Council Assessment Panel

Wednesday 21 August 2019, 9.30 am

5.2.1 SUMMARY DETAILS

Application No.	580/34/19
Applicant	Beyond Ink
Subject Land	LOT: 83 FP: 157218 CT: 5680/436, LOT: 84 FP: 157219 CT: 5802/52, 145C-147 Mount Barker Road HAHNDORF
Ward	North Ward
Proposal	Demolition of the existing dwelling and ancillary structures and construction of an Early Learning Centre (child care and pre-school) including associated covered verandahs, open pergolas, earthworks, car parking, retaining walls, landscaping and fencing
Zone	Township Zone
Policy Area	Residential Policy Area 21
Historic Conservation Area	Hahndorf, North Approaches Area 14
Form of Assessment	Merit
Public Notification	Category 3
Representations	Two (2)
Persons to be heard	Two (2)
Agency Consultation	• Commissioner of Highways - Department of Planning, Transport and Infrastructure (DPTI)
Responsible Officer	Michael Dickson
Main Issues	• Suitability of Land Use within the Zone and Policy Area • Built form and Appearance • Car Parking, Transport and Access • Noise impacts • Historic Conservation Area • Trees and Landscaping

SITE PLAN

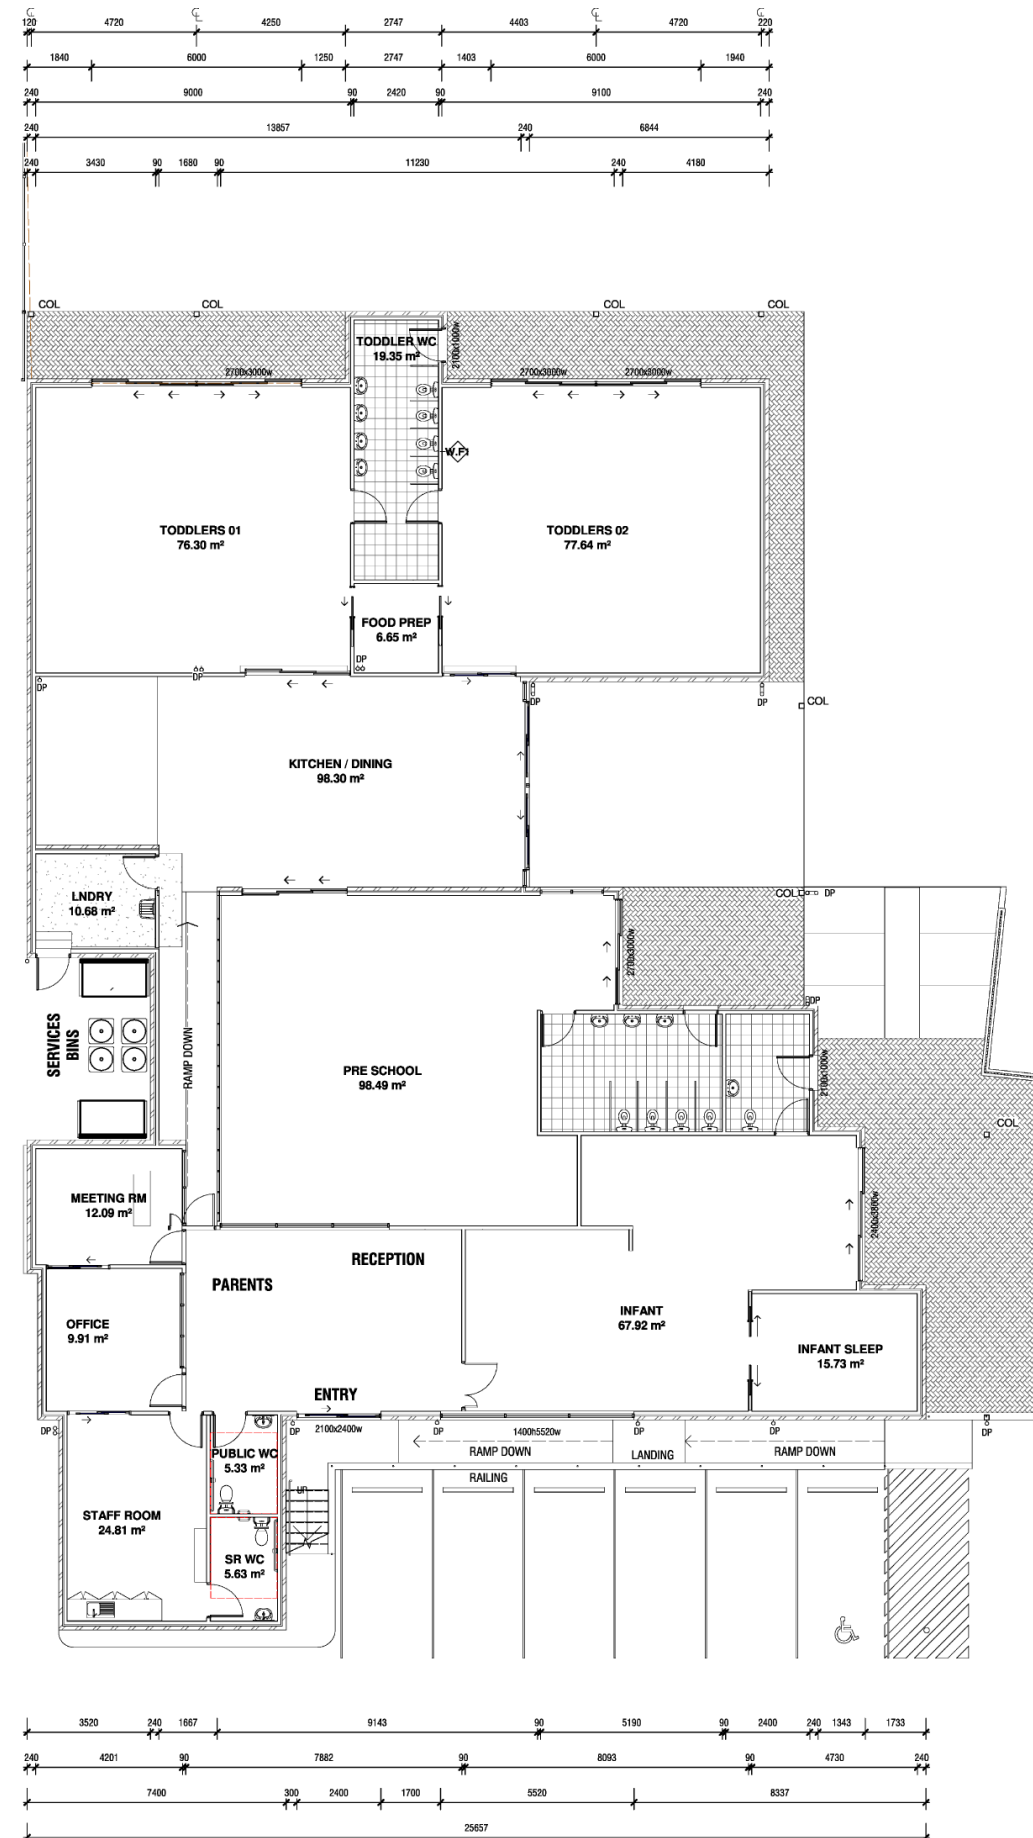
- (2) The English Oak Tree (significant tree), as detailed as the 'Existing Tree' on the Site Plan by Beyond Ink (Sheet no. PL01, Revision E, 05 August 2019), shall be retained and no 'Tree Damaging Activity' shall be caused to the tree including the killing, destruction, removal, ringbarking, topping, lopping, severing of branches, limbs, stems or trunk, or any other substantial damage unless otherwise approved in writing by Council.

- (3) The following measures must be undertaken in order to preserve and maintain the health of the English Oak Tree (significant tree), as detailed as the 'Existing Tree' on the Site Plan by Beyond Ink (Sheet no. PL01, Revision E, 05 August 2019), during demolition and construction works:

- b. The ‘Outdoor Play’ area as detailed on the Site Plan (Sheet no. PL01, Revision E, 05 August 2019) by Beyond Ink, must not be used prior to 7.00am on any day.

- (14) The access points shall be located and constructed in accordance with the site plan provided by Beyond Ink, Sheet No. PL01, dated 15 April 2019.
- (15) All vehicles must enter and exit the site in a forward direction.
- (16) All on-site vehicle manoeuvring areas shall remain clear of any impediments.
- (17) Stormwater run-off shall be collected on-site and discharged without jeopardising the safety and integrity of Mount Barker Road. Any alterations to the road drainage infrastructure required to facilitate this shall be at the applicant's expense.

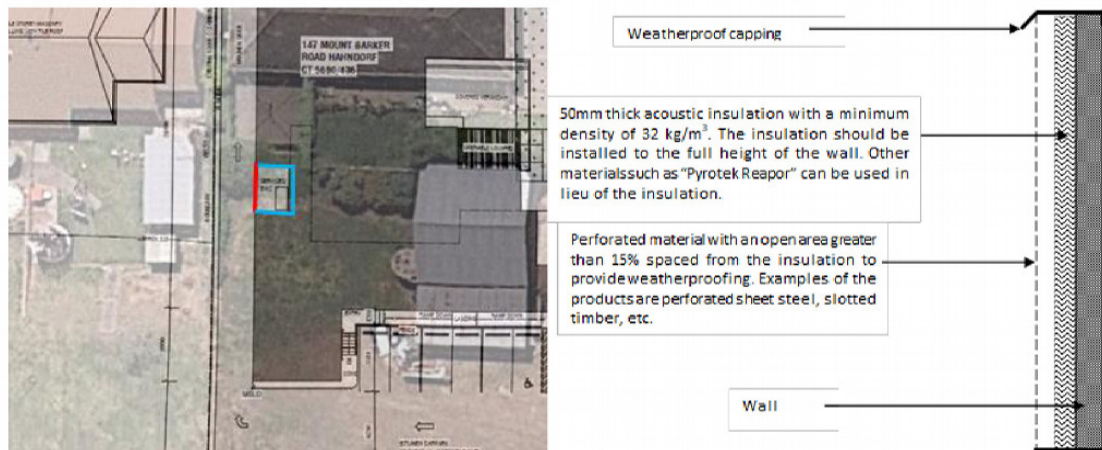
- Increase the height of the currently proposed fence shown as **RED** below to 2.4m. The fence should be sealed airtight at all junctions, including at the building walls and constructed from a material

such as solid timber, as documented, provided the thickness is chosen to ensure a minimum surface density of 4.5kg/m^2 or sheet steel ("Colorbond") of minimum 0.42 BMT
